Rezoning Transportation Analysis

Petition Number: 2020-087

General Location Identifier: Tax ID 03904210

Date	Description
07-22-20	First Review
08-25-20	Second Review

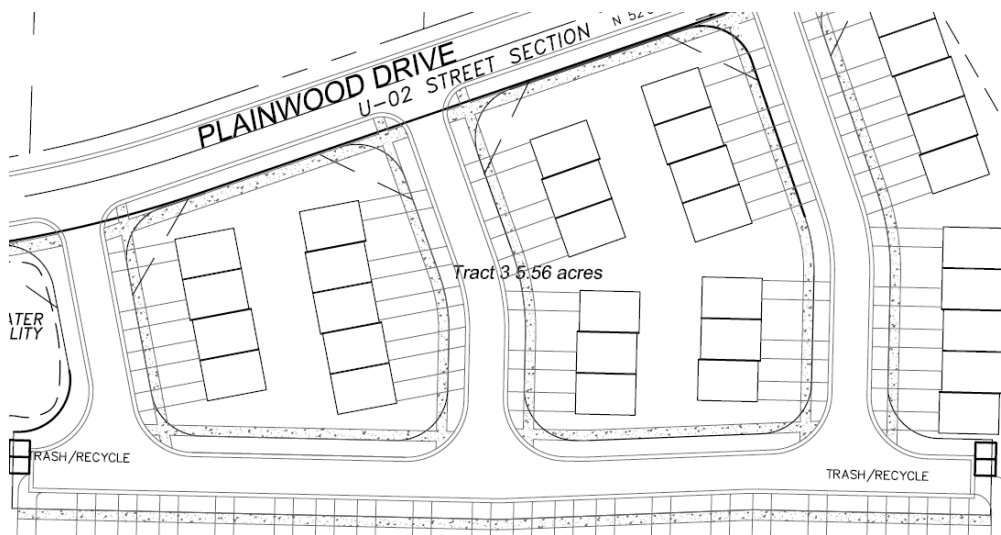
- ~~1. **Traffic Study** A Traffic Impact Study is not necessary for the complete review of this petition. If during the permitting process the site generates more than 2500 daily trips, then a traffic study will be required.~~
- ~~2. The petitioner should revise the site plan and conditional note(s) to commit to dedicate 50 feet of right-of-way from the road centerline of Brookshire Boulevard, which is classified as a major thoroughfare within the Comprehensive Transportation Plan. The site plan should label and dimension the right-of-way from the road centerline.~~
- ~~3. The petitioner should revise the site plan and conditional notes to revise all units fronting public streets to be alley-loaded.~~
 - Technical Clarification (site plan dated 8-17-20)** The petitioner should clarify which streets are proposed to be private streets on the revised site plan.

- Technical Clarification (site plan dated 8-17-20)** The petitioner should revise the site plan to condense the number of front-loaded driveways along Black Avenue, and please clarify that this street will be public.

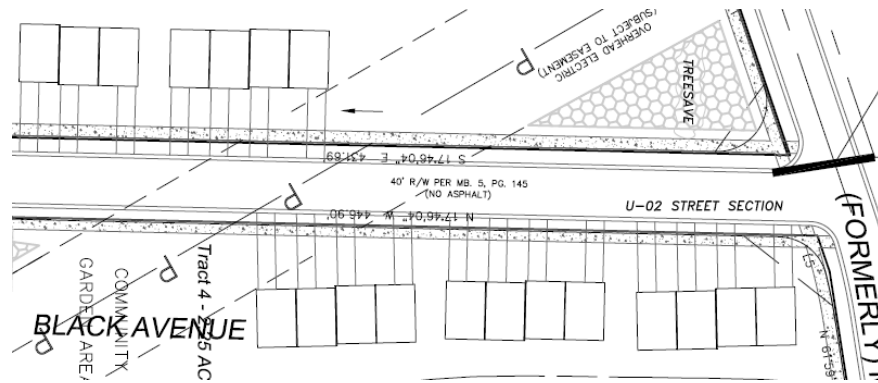
4. The petitioner should revise the site plan and conditional note(s) to commit to construct an 8-foot planting strip, and 6-foot sidewalk on Plainwood Drive per Chapter 20 Subdivision ordinance. The site plan should label and dimension both items from the back of curb and gutter and road centerline.

- a. **Technical clarification (site plan dated 8-17-20)** The petitioner should revise the site plan to show and call-out the 8' planting strip and 6' sidewalk, in reference to conditional note **(Section E.1.)**
